Access Compliance Report

Public Rights-of-Way

(Curb Ramps)

Intersection ID: 11129	Main Street: BECKWITH_PL	Cross Street: NEWELL_AV	Location: SE
ADA ID: 96659619C51F	Ramp Type: PerpDiag	Initial Pass/Fail: Pass	Overall Compliance: No
Severity Score: 42.5			
Codes/Mitigation Info/Possible Solution		Field Measurements/Component Compliance

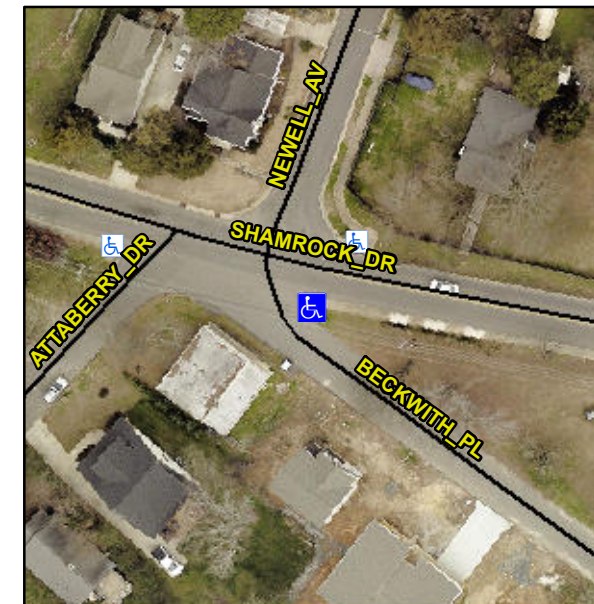
Not Found, R304.5.1, R304.5.3, R304.2.1, R304.2.2-Perp, R304.3.2-Para, R305, R302.7.2, R304.5.4

Compliance	Description	Data	Compliance	Description	Data
N/A	Ramp Length (in)	60.0	Yes	Ramp Slope (%)	7.9
No	Ramp Width (in)	24.0	No	Ramp XSlope (%)	10.0
N/A	Flare Type LT	Sloped	N/A	Flare Type RT	N/A
N/A	Flare Slope LT (%)	8.9	N/A	Flare Slope RT (%)	10.6
N/A	Flare Traversable LT?	Yes	N/A	Flare Traversable RT?	No
No	Landing Length (in)	N/A	No	DWS Provided?	No
No	Landing Width (in)	N/A	N/A	DWS Contrast?	No
No	Landing Slope (%)	N/A	N/A	DWS Length (in)	N/A
No	Landing X Slope (%)	N/A	N/A	DWS Full Width?	No
N/A	Landing Curb? (Y/N)	No	N/A	DWS Offset (in)	N/A
N/A	Shared Landing?	N/A			
Yes	Gutter Ponding?	No	No	Gutter Slope (%)	6.5
No	Gutter Lip Ht (in)	0.5	No	Gutter X Slope (%)	6.8
N/A	Painted X Walk1?	No	N/A	Painted X Walk2?	No
	X Walk 1 Direction	To NW		X Walk 2 Direction	To N
N/A	X Walk 1 Width (in)	N/A	N/A	X Walk 2 Width (in)	N/A
	X Walk 1 Slope (%)	14.4		X Walk 2 Slope (%)	24.3
	X Walk 1 X Slope (%)	3.4		X Walk 2 X Slope (%)	4.1

N/A	Ramp inside XWalk1?	N/A	N/A	Ramp inside XWalk2?	N/A
	Road Slope (%)	3.4	N/A	Clear Space?	Yes
	Road X Slope (%)	9.9	N/A	Clear Space to XWalk (in)	N/A
Yes	Any Obstructions?	No	Yes	Storm Grate/Utility Hazard?	No
	Obstruction Type			Storm Grate/Utility Type	
		N/A			N/A
			Yes	Surface Condition? (G/P)	Good

Remove & Replace Curb Ramp With Two New Directional Ramps or Equivalent. Remove & Replace Gutter.
